UNITED STATES PATENT AND TRADEMARK OFFICE

APPLICATION NO.	FILING DATE	FIRST NAMED INVENTOR	ATTORNEY DOCKET NO.	CONFIRMATION NO.
10/724,375	11/26/2003	Zhi-Min Choo	2060-3-85	9666

Office Action Summary	Application No. 10/724,375	Applicant(s) CHOO, ZHI-MIN	
	Examiner Richard M. Bemben	Art Unit 2622

DETAILED ACTION

Modified Figure 5 from applicant's specification

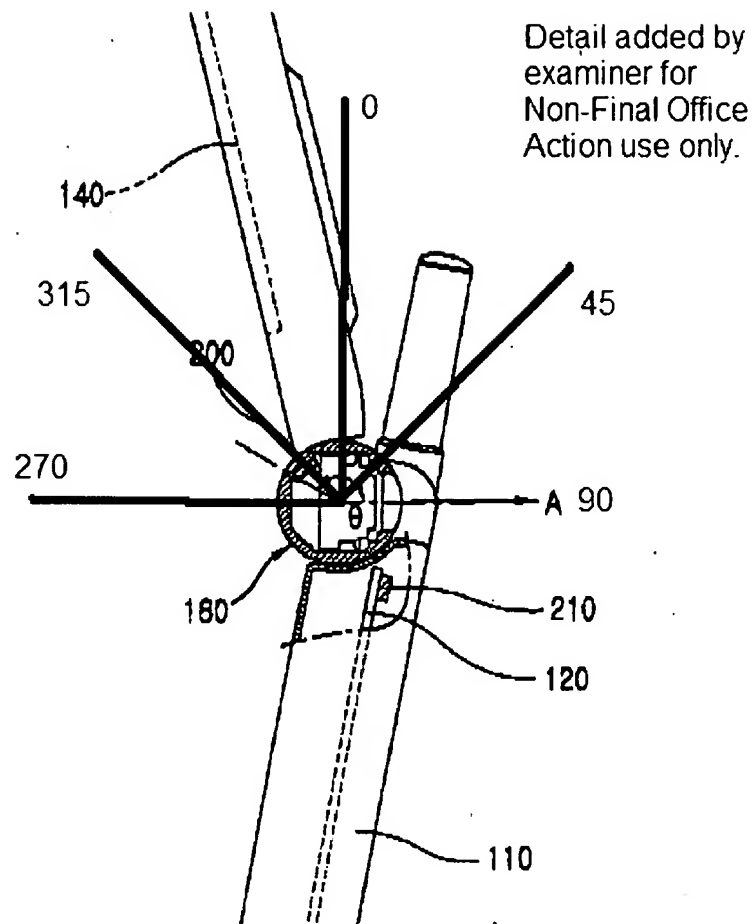
Applicant's specification (US 2004/0110541) requires photographic apparatus 160 to have a range of motion of 180° ([0030]). Referring to paragraphs [0034] & [0035] and Figures 5 & 6, the limits of the photographic apparatus' rotation are unclear. For instance, if direction "A" in Figure 5 is 90° and the photographic apparatus can rotate 180° , in order to be able to capture images of both the user and the scene at 90° , the photographic apparatus must only rotate between 270° and 90° , through 0° (which is the 180° rotation required). This is shown below:

According to [0034], if the photographic apparatus is rotated from 330° to 90° , the rotation angle is less than or equal to 150° . First, rotation between 330° to 90° is less than or equal to 120° . Second, it appears that the 150° rotation ends at direction "A" or 90° . However, [0035] appears to require the photographic apparatus to rotate at an angle exceeding 150° (it is unclear where the 150° starts and ends, it is assumed by the examiner that the 150° ends at 90° according to Fig. 5). As described above, if the photographic apparatus can only

rotate between 270° and 90° through 0°, then the rotation angle cannot exceed 150° (if 150° ends at 90°).

Appropriate clarification and/or correction is required.
